s110_nrf51 migration document

This document describes how to migrate to new versions of the s110_nrf51. The s110_nrf51 release notes should be read in conjunction with this document.

SoftDevice size:

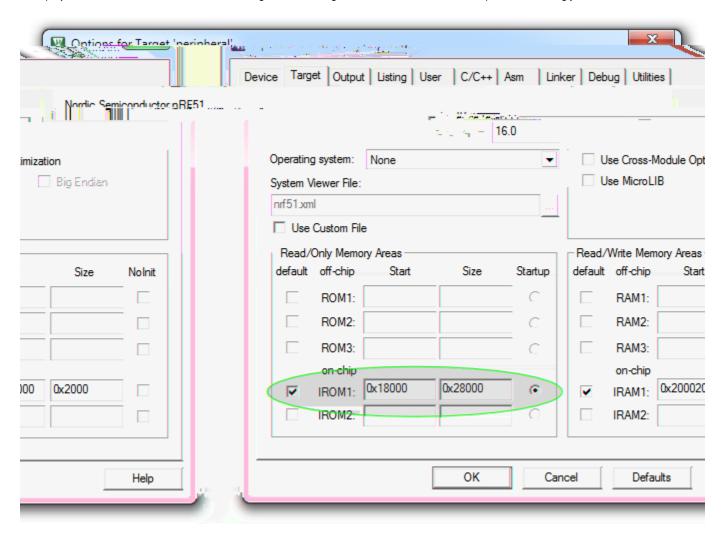
The size of the SoftDevice has changed requiring a change to the application project file. The new size (including MBR) is 96 kB.

- Go into the properties of the project and find the Target tab
- Change IROM1 Start to 0x18000
- Ensure that the IROM1 size is no more than 0x28000 (for the 256 kB IC variants).

SoftDevice size

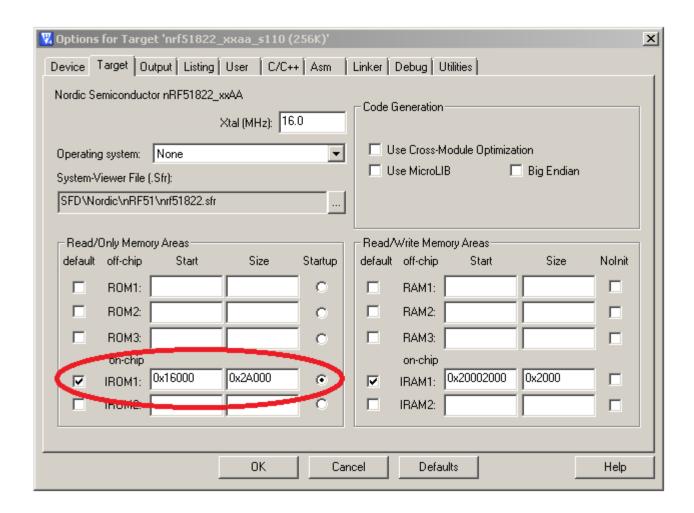
The size of the SoftDevice has changed requiring a change to the application project file.

- Go into the properties of the project and find the Target tab
- Change IROM1 Start to 0x16000
- Ensure that the IROM1 size is no more than 0x2A000
